PROPOSED DEVELOPMENT AT BOHERBOY, SAGGART, CO. DUBLIN

Road Safety Audit Stage 1/2

Project Title	Proposed Development at Boherboy, Saggart, Co Dublin
Project No.	25201-01
Document Title	Road Safety Audit Stage 1/2
Document No.	25201-01-001

Figure 2.1 – Visibility Splays at Boherboy Access

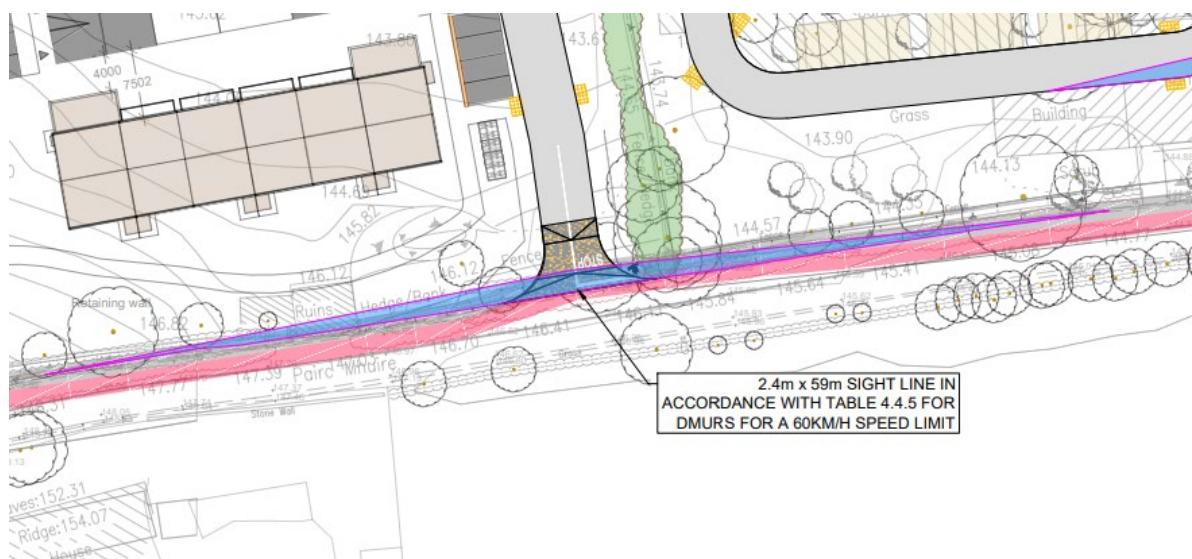
Visibility splays from the proposed access onto Boherboy Road may be obstructed by existing trees, and roadside boundaries either side of the access. Road safety risk is increased in situations where inter-visibility between drivers turning out of an access and drivers approaching on the mainline is restricted. Lack of adequate visibility may increase the likelihood of a collision at the access.

Recommendation: Ensure that adequate visibility splays are be provided at the access and remove all obstructions within the visibility splays.

Figure 2.2 –Visibility Splays at internal Junctions

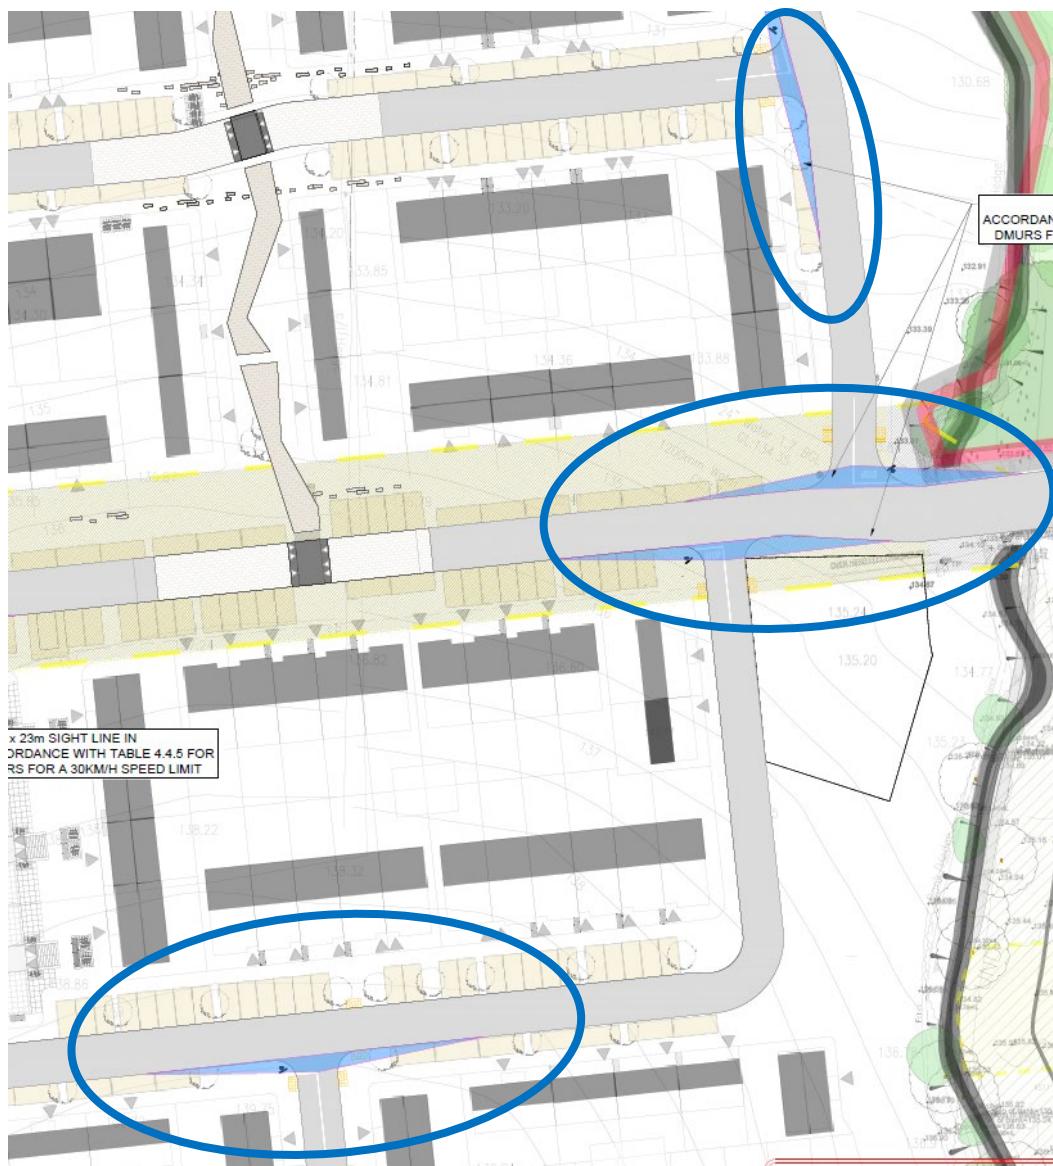
Visibility splays at a number of proposed internal junctions may be obstructed by vehicles parked in the adjacent car parking spaces including but not limited to the locations shown in the image below. Road safety risk is increased in situations where inter-visibility between drivers turning out of an access and drivers approaching on the mainline is restricted. Lack of adequate visibility may increase the likelihood of a collision at these internal junctions.

Recommendation: Ensure that adequate visibility splays are be provided at the accesses and remove all obstructions within the visibility splays.

Figure 2.3 – Compromised Stopping Sight Distance

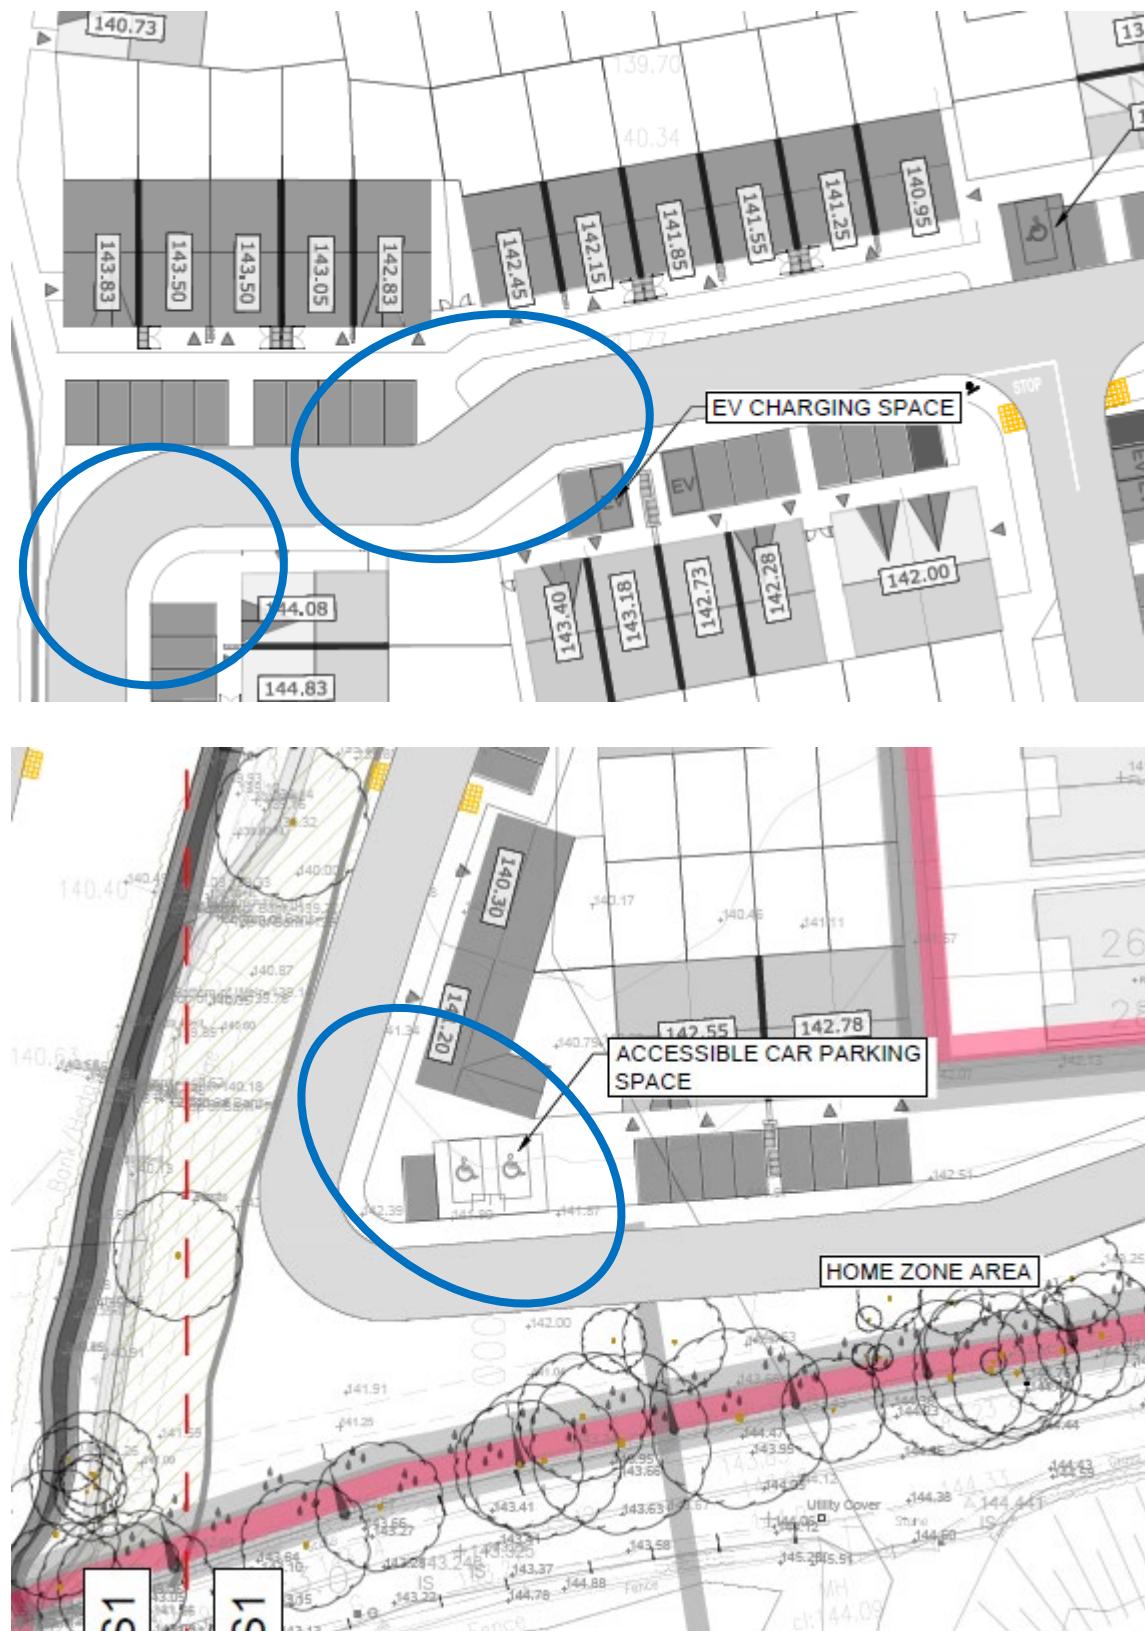
Two opposing vehicles may have difficulty in passing one another at low radius bends within the proposed development including but not limited to the locations shown in the images below. In addition, stopping sight distance may be restricted by a landscaping and parked vehicles on the inside of bends. A lack of appropriate stopping sight distance may contribute to a collision at these locations.

Recommendation: Ensure that two opposing vehicles can pass one another on all low radius bends and ensure that adequate stopping sight distance is available at all locations.

Figure 2.6 – Tactile paving location

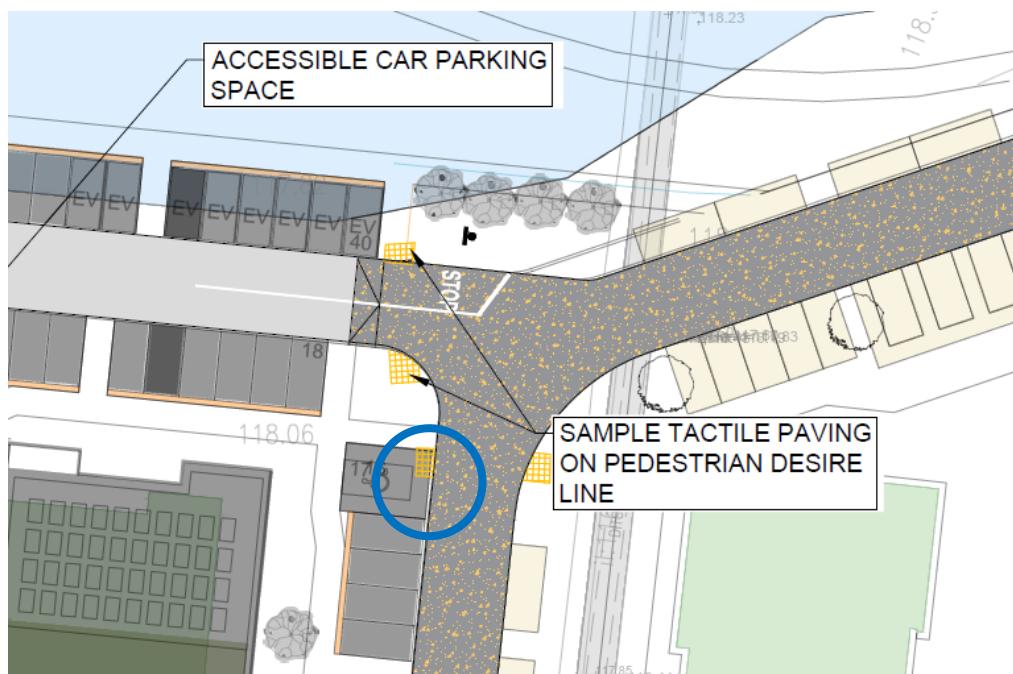
At a number of locations, vehicles turning to and from parking spaces will likely traverse tactile paving at pedestrian crossings. Damaged or broken tactile paving may lead to trip hazards for pedestrians.

Recommendation: Relocate pedestrian crossings away from locations where vehicles will be turning to and from parking spaces.

Figure 2.7 – Compromised pedestrian – Motorist Intervisibility

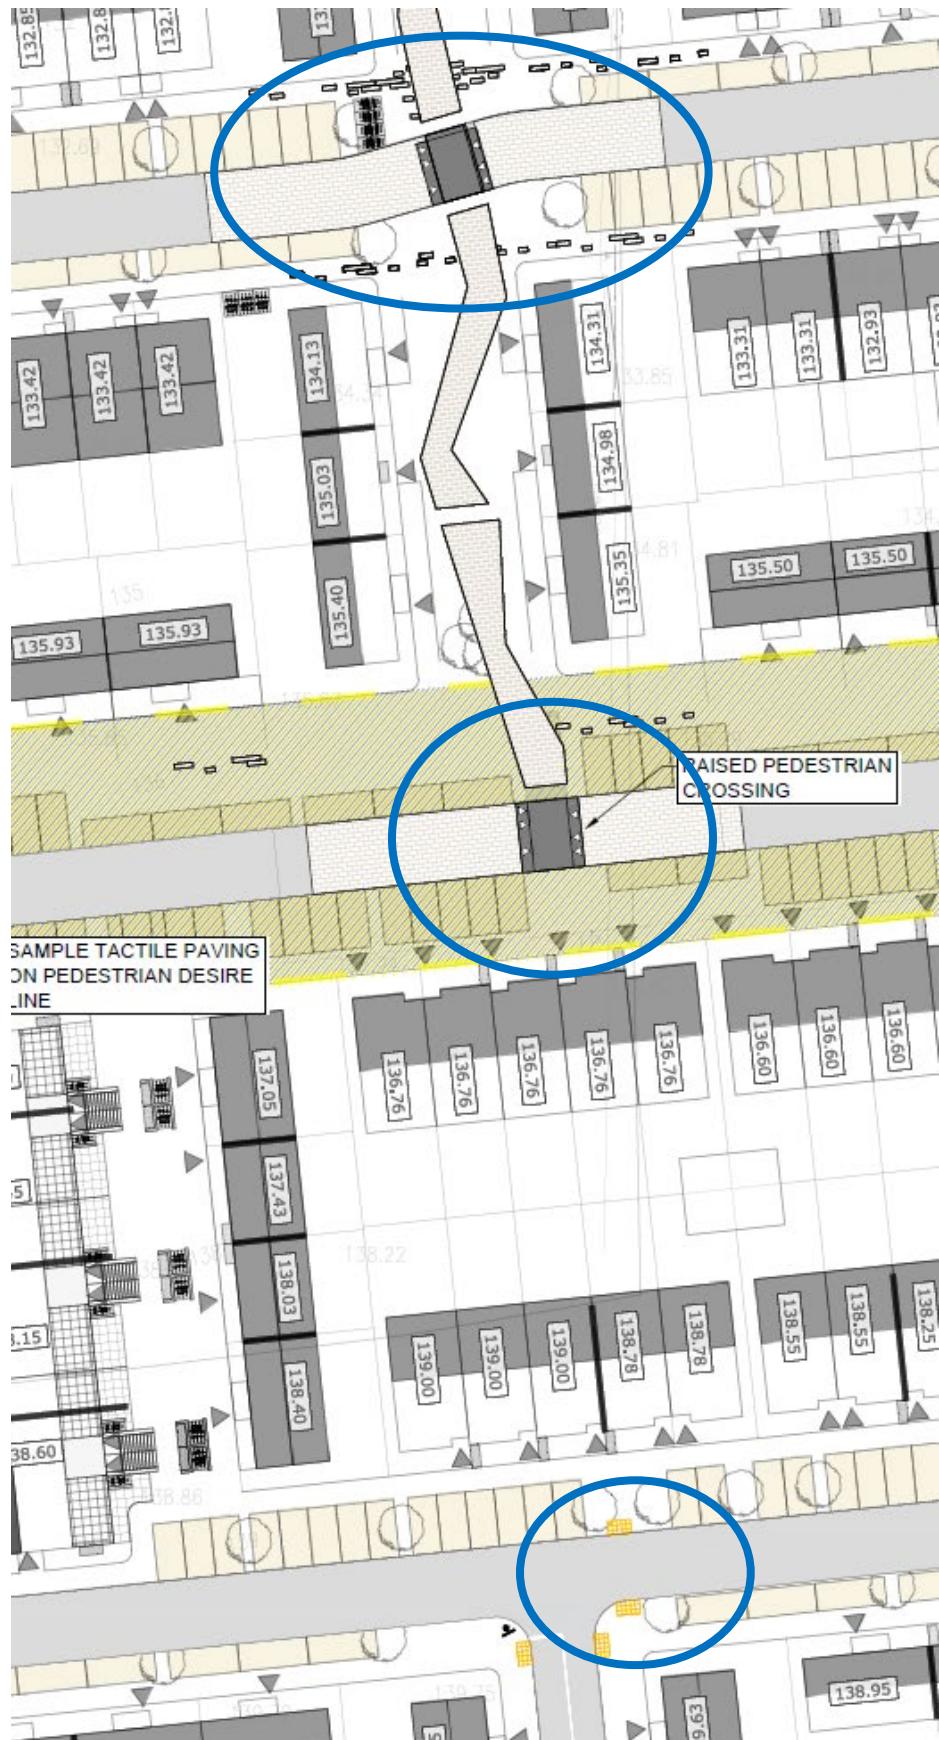
Intervisibility between pedestrians crossing pedestrian crossings and drivers of vehicles approaching the crossings may be restricted by vehicles parked in adjacent car parking spaces at a number of pedestrian crossing locations including but not limited to those shown in the image below. A lack of adequate intervisibility may contribute to a collision at these locations.

Recommendation: Ensure that adequate intervisibility is provided between pedestrians and drivers of vehicles approaching all pedestrian crossing locations.

Figure 2.8 – Raise Table

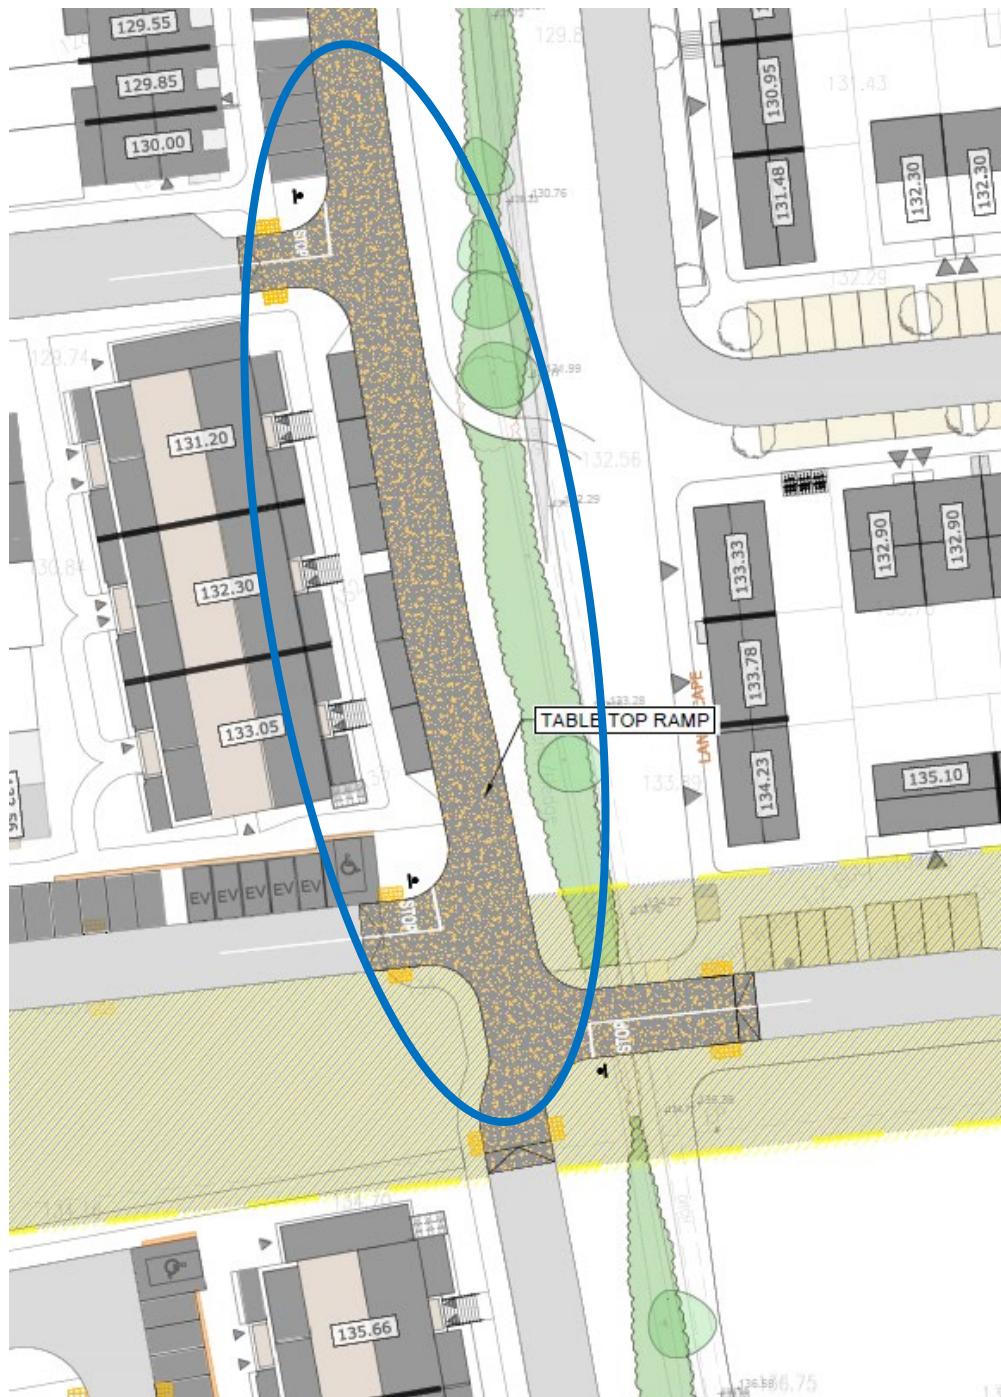
It is unclear what, if any, grade-seperation will exist between footways and vehicular carraigeways where raised streets/tables are proposed. This may lead to navigation challenges for white cane users, who may become disoriented and wander out onto the carriageway in front of moving vehicles.

Recommendation: Ensure adequate grade separation between footways and carriageways at all locations. Alternatively, consider Tactile Paving delineators.

Figure 2.10 – Proposed Swept Path Analyses

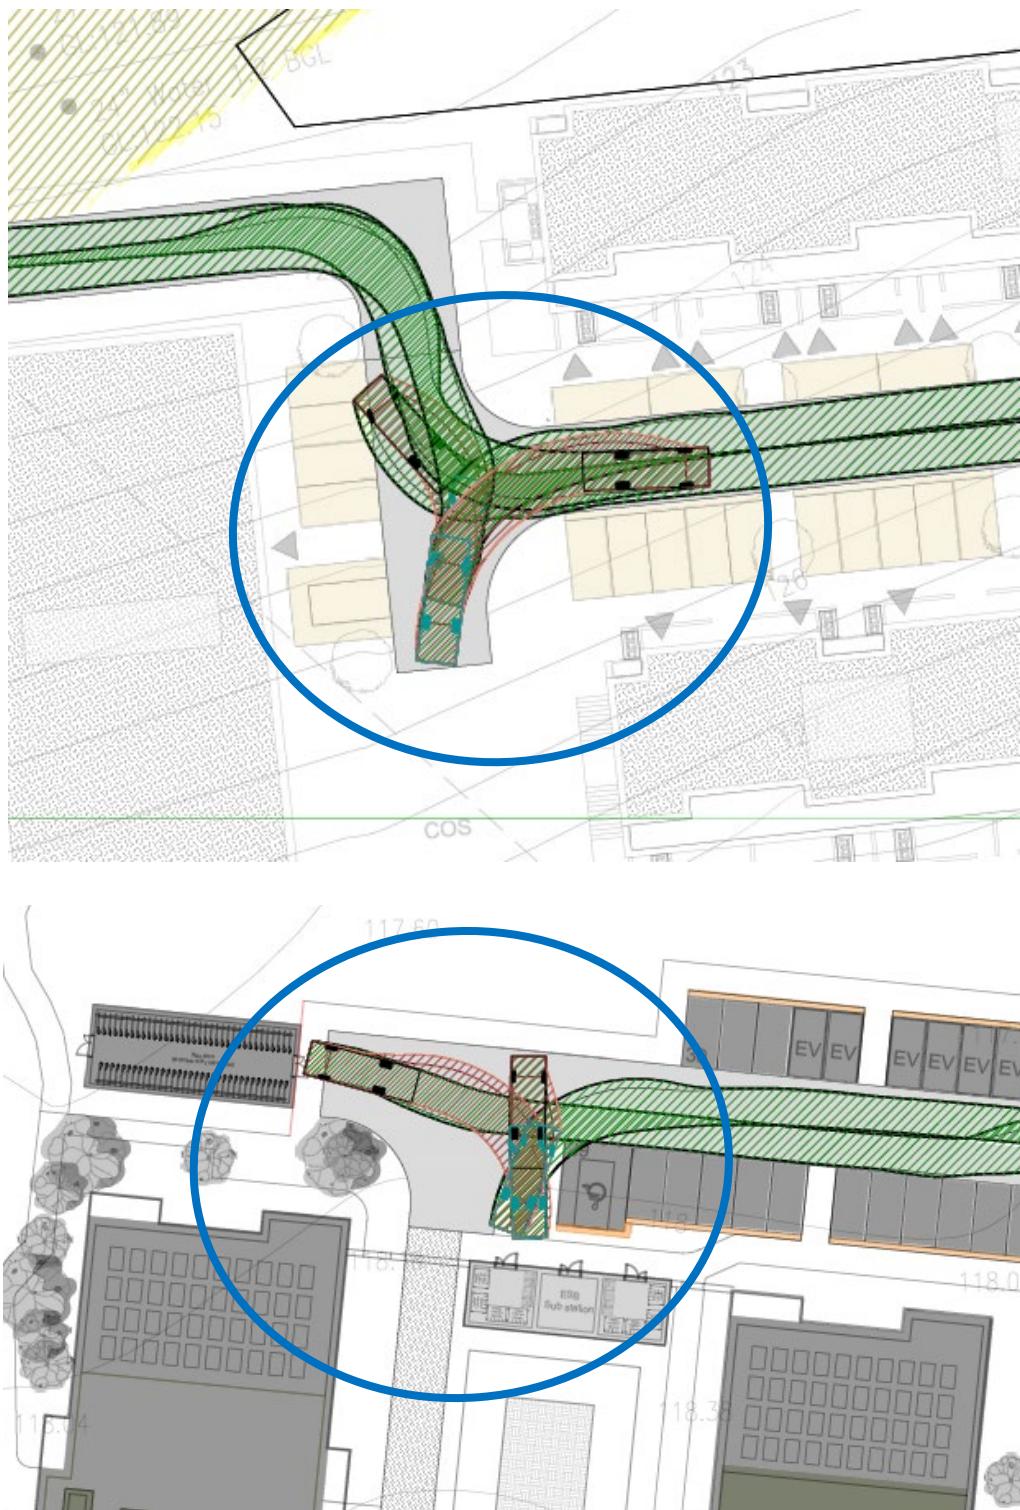
Based on proposed Swept Path Analyses, it is unclear if all required manouevres can be completed without colliding with other vehicles or mounting footways and potentially injuring pedestrians.

Recommendation: Ensure adequate manoeuvring space. Redesign roads as required.

Figure 2.11 – Colour Contrast

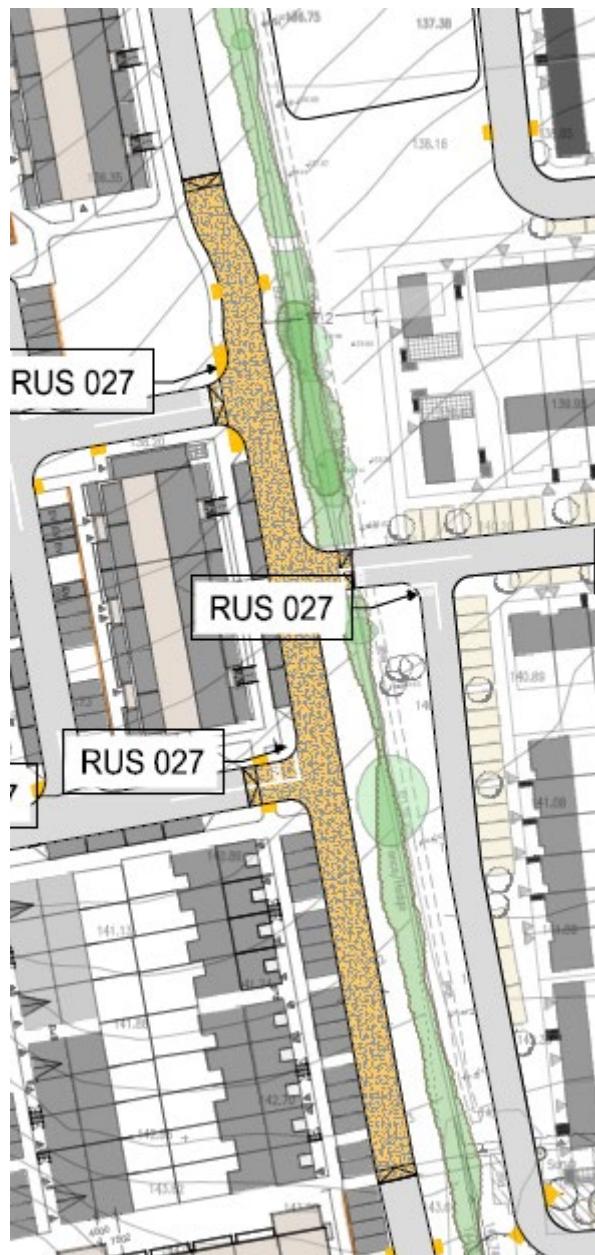
It is unclear what the proposed finished colour surface will be on raised carriageways. Where it is too close to buff colour tactile paving, this may cause confusion for white cane users due to the lack of colour contrast. These users may become disorientated and wander out on front of moving vehicles.

Recommendation: Ensure Adequate colour contrast between tactile paving and surrounding surfaces.
